Reference: Case No. PD-270-RBN, The Avenue at Denton Tap, a zoning change request from Commercial to a Planned Development to allow 29 multifamily units and 8,575 square feet of office/retail uses on 1.77 acres of property located at the northwest corner of Southwestern Boulevard and South Denton Tap Road.

STAFF REPORT

CASE NO. PD-270-RBN, The Avenue at Denton Tap

The Avenue at Denton Tap

Site Plan

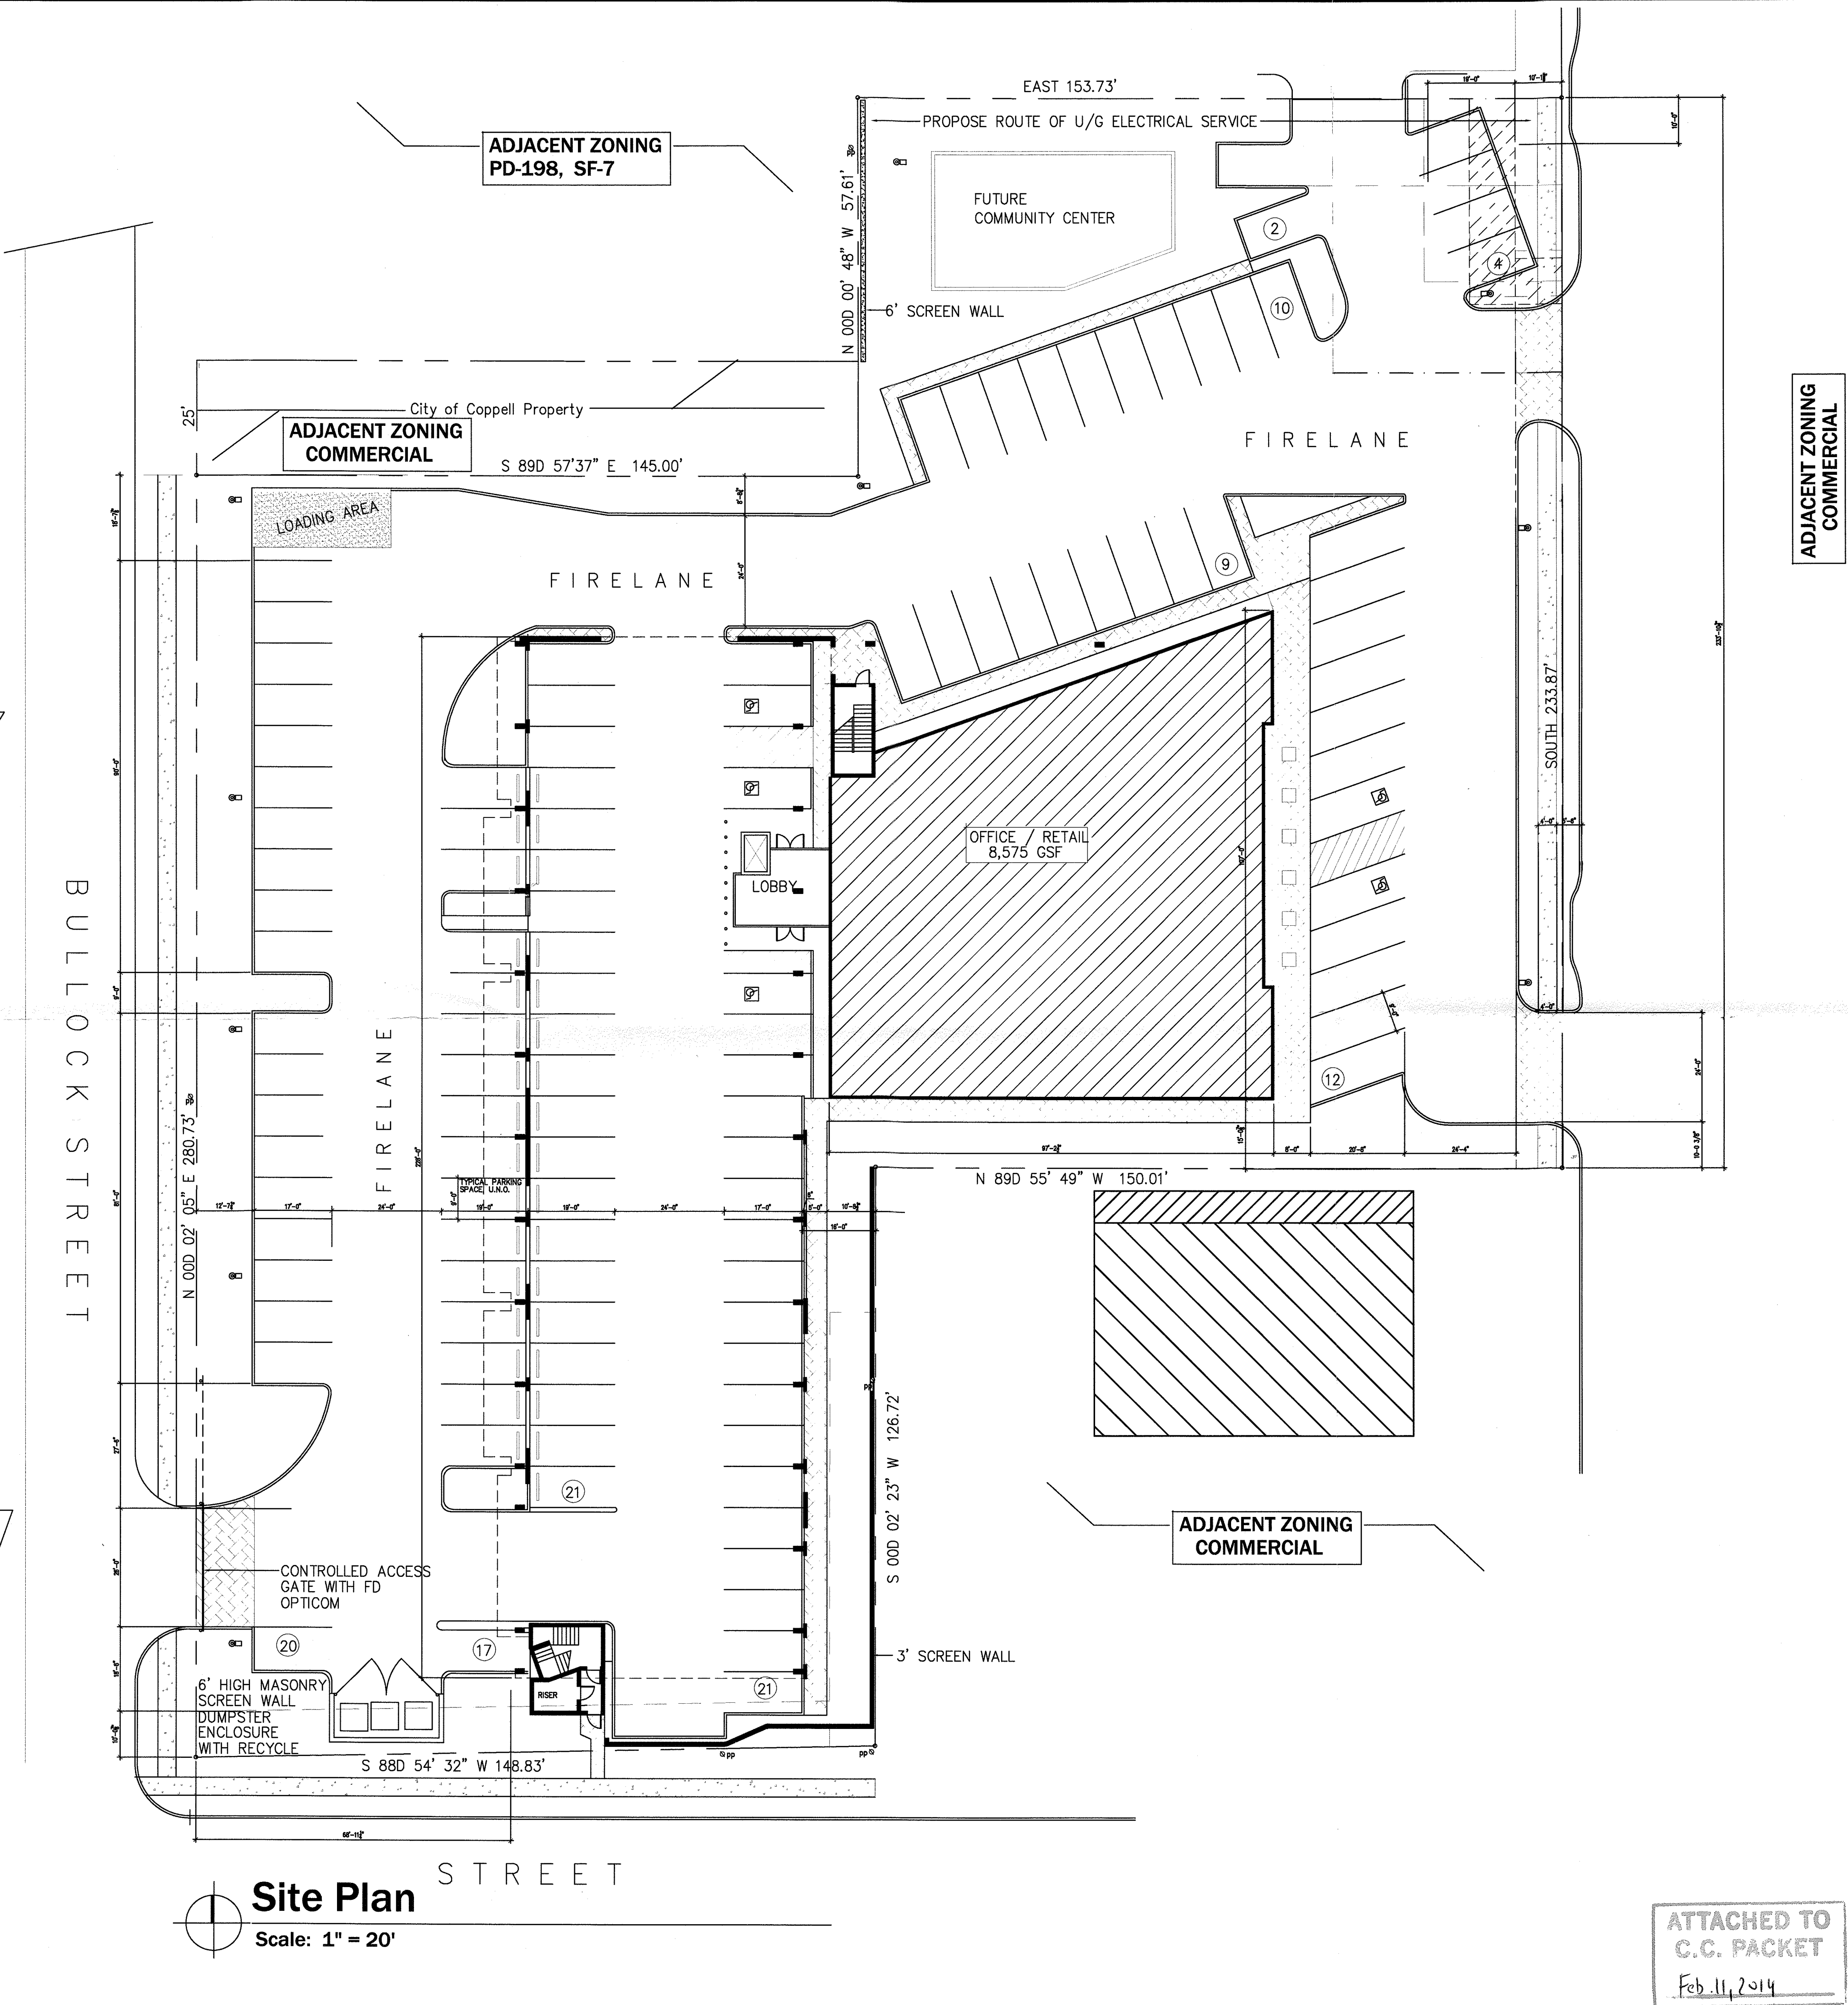
A 36-foot setback is proposed along the northwest property line, which is adjacent to a 25-foot right-of-way providing a greater separation from the residential neighborhood. The main building is 63 feet from the Denton Tap Road right-of-way where the RBN District calls for a building to be no more than 15 feet from the lot line. Staff can support this deviation, as both a drive and parking are warranted for the office/retail use.

This proposal exceeds the 116 parking space requirement by providing 119 spaces. Both the *Comprehensive Plan* and the RBN District encourages structured (garage) parking. In this development 41 of the 119 spaces are contained within the structure. It is recommended that this parking area on the first floor be better screened with a three-foot masonry wall incorporated into each façade and this has

been listed as a condition of approval. Beyond the structured parking are 41 spaces in a parking lot. This area is proposed to be screened with a 12 foot wide landscaped area east of Bullock Street. The proposed off-street parking and drive (similar to a slip street recognized in the Comprehensive Plan). The proposed parking located on the Denton Tap Road side is angled with a one-way drive to provide an opportunity for streetscaping without actually having dangerous on-street parking on Denton Tap.

1. BUILDING IS GREATER THAN 15 FEET FROM DENTON TAP ROAD.
2. DRIVEWAY RUNS PARALLEL TO DENTON TAP.
3. PARKING EXITS ALONG DRIVE.
4. 12-18A-2, HEIGHT OF BLDG IS 36'.
5. 12-18A-2.b: ROOF HEIGHT OF MOST NORTHWEST CORNER IS 26'-4" ABOVE FINISH FLOOR.
6. 12-18A-3-a.2: WEST PARKING IS BEYOND FACE OF BLDG DUE TO LARGE SETBACK OF BLDG.
7. FUTURE COMMUNITY CENTER PLANS WILL BE SUBMITTED TO THE DIRECTOR OF PLANNING FOR ADMINISTRATIVE REVIEW PRIOR TO PERMITTING FOR CONSTRUCTION.

1 LANDSCAPE PLAN

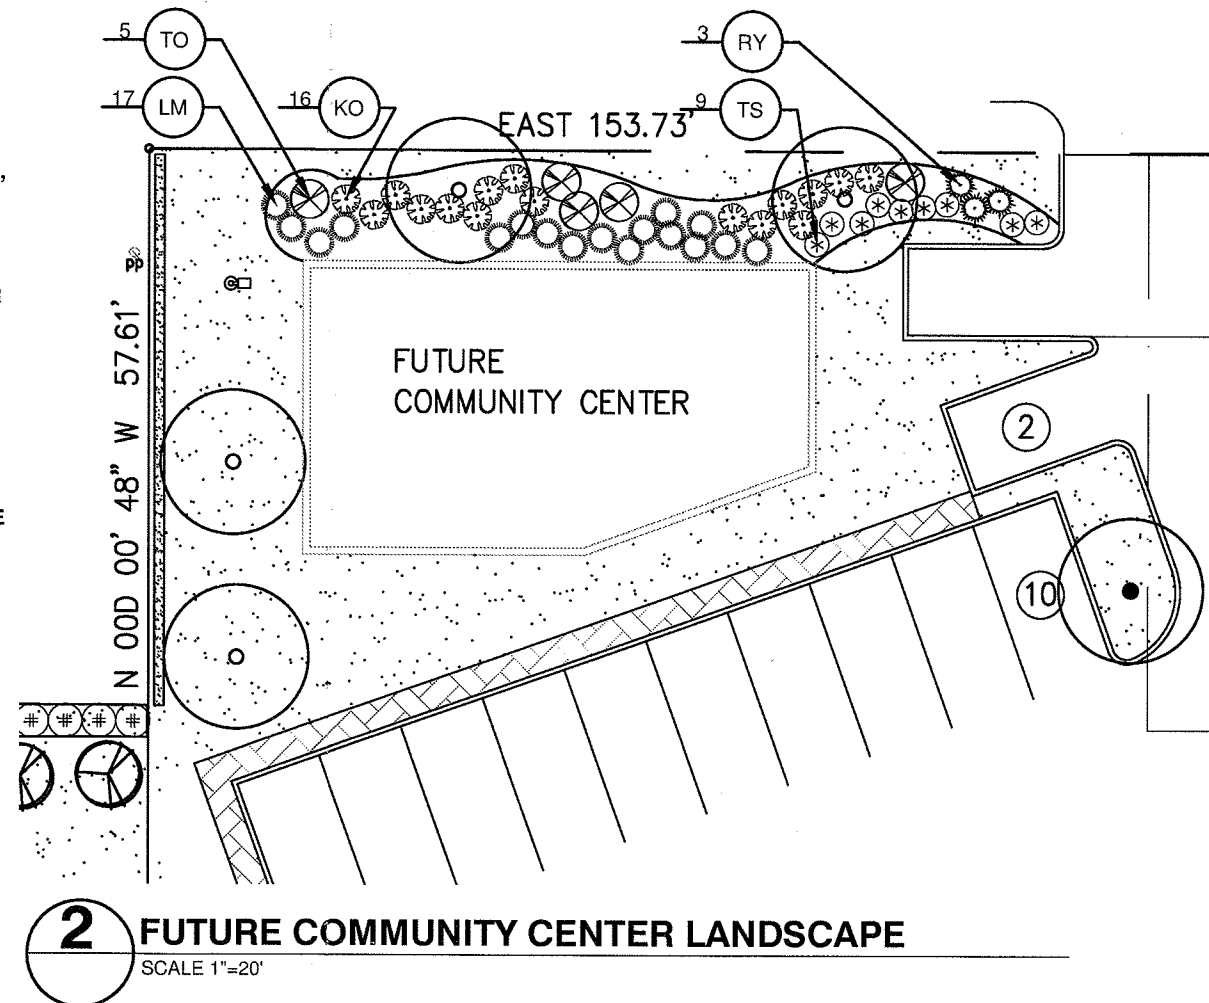
The landscape areas within a RBN District are different than the typical business zoning districts where under the RBN, a minimum 15% open space/common area is required. The proposal indicates that 17% has been provided. The streetscaping of the retail/office area is adequate where street trees are being provided. However, additional landscape islands are being recommended in the parking lot where there is no structure over the parking. Not more than 15 parking spaces are typically permitted without an island and one island is required at the end of each parking row; therefore, three islands are recommended. Also, the applicant has agreed to add an evergreen area of landscaping (containing Nellie R. Stevens and Eastern Red Cedars) to the 25 foot right-of-way strip located northwest of the property to better buffer/screen this proposal from the existing residential neighborhood.

| 12. | Label the 25-foot right-of-way northwest of the site as City of Coppell Property. Include Eastern Red Cedars and Nellie R. Stevens south of the existing fence. |
| 15. | Revise the Landscape Plan to include interim and future landscaping for the "Future Community Center" portion of the site. |

01 Elevation at Sliding Gate
Scale: 1/4" = 1'-0"

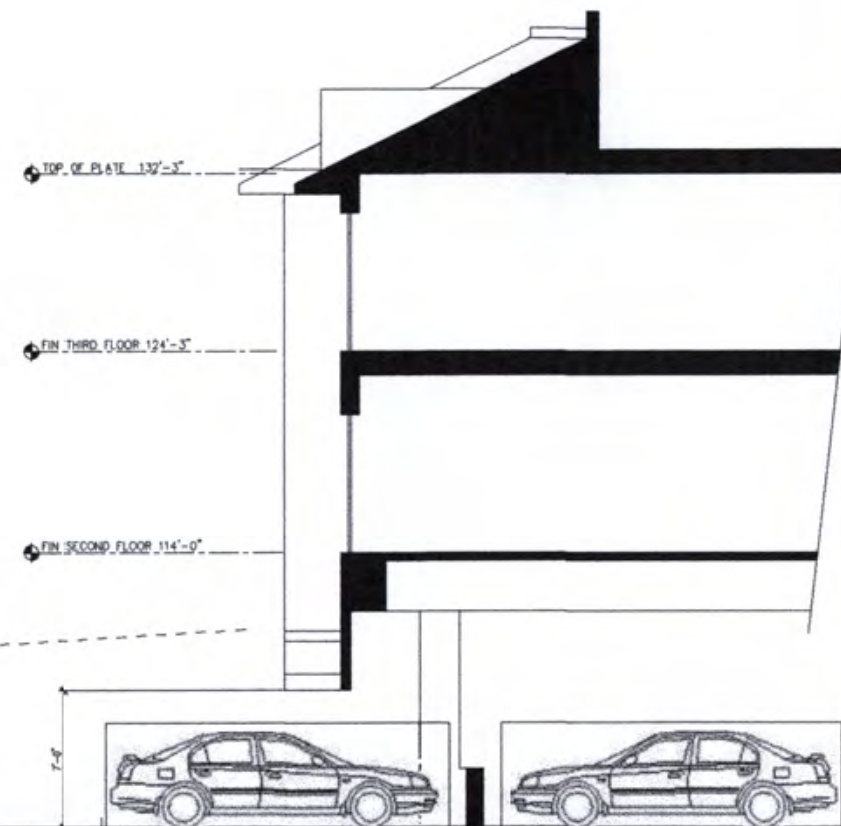
| 16. | Include a gate with controlled access (include opticom for Fire Department) at the southwest access point off of Bullock. |
